Appendix - Shenstone Park Part B Submission

VPA Response to Donnybrook Joint Venture preferred Future Urban Structure (responding to panel direction dated 5th November 2020)

Figure 8 - VPA proposed Plan 11 Public Transport and Pathways (VPA Part A FUS)

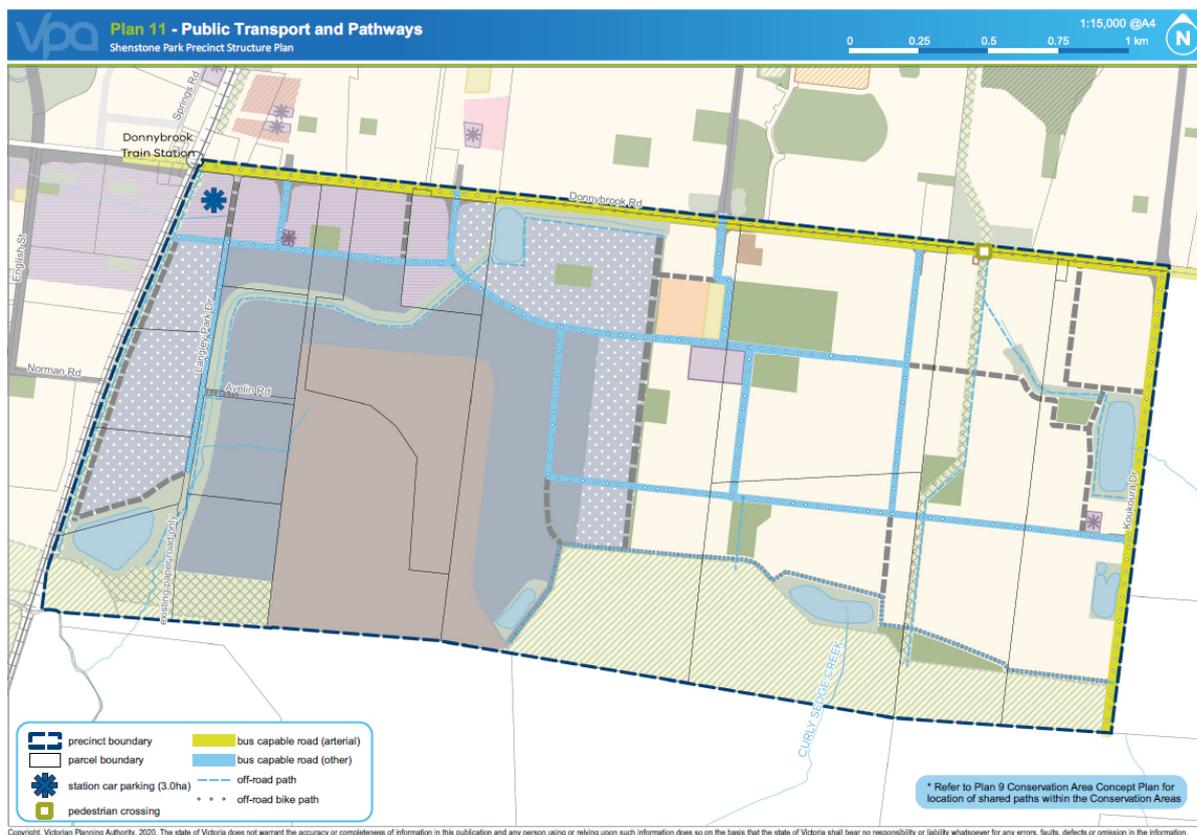
VPA does not support the internal road network as shown in the proposed DJV FUS. The key change proposed in the DJV FUS is the removal of an east west connector road through the precinct. Figure 8 shows the VPA proposed Public Transport and Pathways Plan (Plan 11) from the Part A PSP. It is important to note that the connector road network also provides an off road bike path to encourage active transport within the precinct. A reduction in the connector road network in the precinct will discourage active transport which is not desirable in proximity to Donnybrook Station.

The connector road network also provides a network of bus capable roads in the precinct (Figure 8). Based on preliminary analysis by VPA, the connector road network proposed by DJV may reduce accessibility to the bus network which may increase car dependency within the precinct.
